RE: PCN # ESU270-37 – SP402x series new wafer foundry and alternative backend manufacturing location approval

Product/Process Change Notice (PCN)

PCN#: ESU270-37 **Date:** March 4, 2016

SP402x series of TVS Diode Array Products

3.2 Material Changes

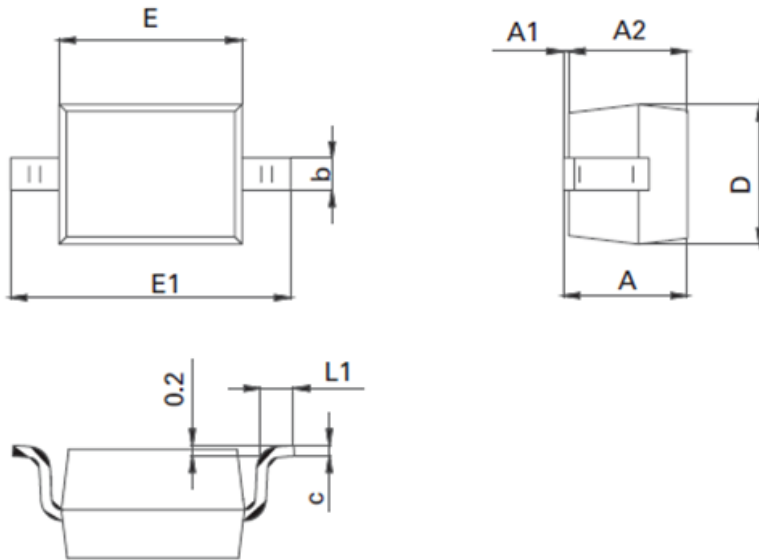
Add two alternative backend locations for SP4020-01FTG, SP4020-01FTG-C, SP4021-01FTG and SP4021-01FTG-C as below table.

Material	Original Backend Location		New Backend Location 1		New Backend Location 2		Changed ?
	Located in China		Located in China		Located in China		
	Material Name	Supplier	Material Name	Supplier	Material Name	Supplier	
Leadframe	N42	Shuen Der Industry	N42	Shuen Der Industry	A42	ASM	Yes
Die Attach Material	84-1LMISR4	Henkel	Eutetic	--	Eutetic	--	Yes
Au Wire	Gold Wire	Heraeus	Gold Wire	MK Electron	Gold Wire	MK Electron	Yes
Molding Compound	ELER-8-100HFE	E'Dale	ELER-8-100HFE	E'Dale	EME-G600	HHCK	Yes
Lead Finish	Tin	Yunnan	Tin	ShangHai SinYang	Tin	Suzhou Nuonengda	Yes

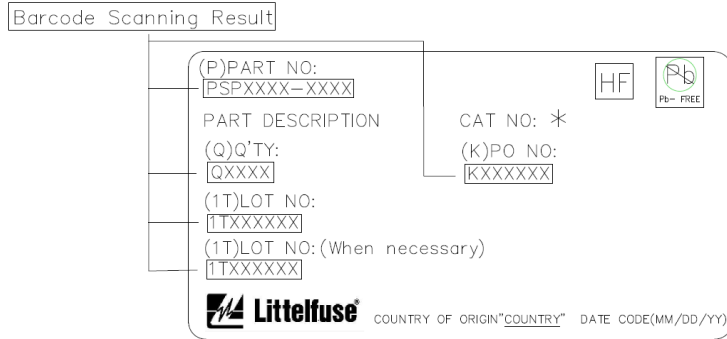
Lead dimension of new backend locations differ from the original backend location.

Original Supplier		Alternative Supplier-1		Alternative Supplier-2	
	Min	Max	Min	Max	Min	Max
A	0.80	1.00	--	1.00	--	1.00
A1	0.00	0.10	0.02	0.10	0.00	0.10
A2	0.80	0.90	--	0.90	0.80	0.90
b	0.25	0.35	--	0.30	0.25	0.35
c	0.08	0.15	0.10 Typical		0.08	0.15
D	1.15	1.45	1.20	1.40	1.20	1.40
E	1.60	1.80	1.60	1.80	1.60	1.80
E1	2.50	2.70	2.55	2.75	2.50	2.70
L1	0.25	0.40	0.22	0.42	2.50	4.00
